UNITED STATES PATENT AND TRADEMARK OFFICE

APPLICATION NO.	FILING DATE	FIRST NAMED INVENTOR	ATTORNEY DOCKET NO.	CONFIRMATION NO.
10/813,828	03/31/2004	Alfred Tondreau	DMF-227-B	5069

Office Action Summary

DETAILED ACTION

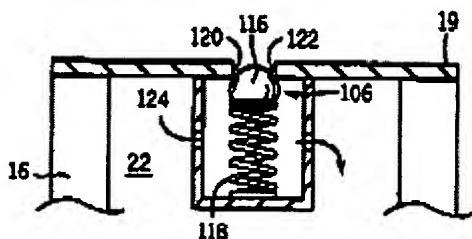
Prater discloses a filter apparatus for filtering diesel fuel [as in claims 4 and 14] including a transparent outer housing 26, a filter element, a cover 50 covering the upper portion of the element a relief valve 102 in the top of the element, wherein the cover is completely impervious (col. 6, lines 64-65) [as in claim 1]. The volume of captured air is of course

governed by Boyles law. The apparatus is configured such that upon reaching a maximum differential pressure across the filter element, the relief valve opens, causing fluid level in the housing to rise, thereby indicating the condition of the filter [as in claims 11]. Also, the spacing between the housing and filter cover is less at an upper portion of the housing [as in claims 2 and 12].

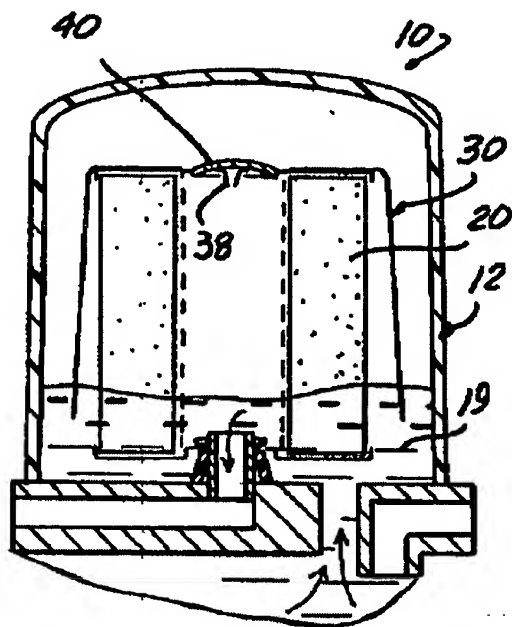
7. Claims 1, 4, 7, 11, 14 and 17 are rejected under 35 U.S.C. 102(e) as being clearly anticipated by Smith et al. (U.S. 6,841,065).

10 The present invention provides a fluid filter assembly that provides an accurate indication of the remaining usefulness of a filter element. The present invention provides a vertical, transparent housing having a fuel inlet for communicating fluid into the housing and a fluid outlet for communicating fluid downstream of said housing. A filter element is disposed within the housing between the fluid inlet and the fluid outlet for filtering the fluid. A means for maintaining and relieving a predetermined level of pressure across the filter element provides an accurate visual indicator as to whether the filter element needs replacement.

FIG. 2 shows a fluid filter assembly 10 of the present invention in its preferred form. The fluid filter assembly 10 is best suited for filtering and processing diesel fuel, but the fluid filter assembly 10 may also be utilized with other fluids, such as gasoline, oil, water, antifreeze, etc. The fluid

Fig. 1

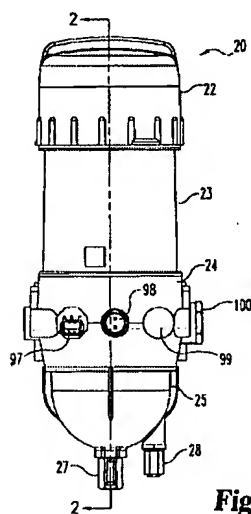
Jiang teaches ribs on the outer surface of his housing cover [as in claims 3 and 13]. It is considered that it would have been obvious to one ordinarily skilled in the art at the time of the invention to such ribs on the outer housing surface of Prater since such would increase friction when producing a rotating motion to remove or replace the cover. The covers of both Prater and Jiang include threads.
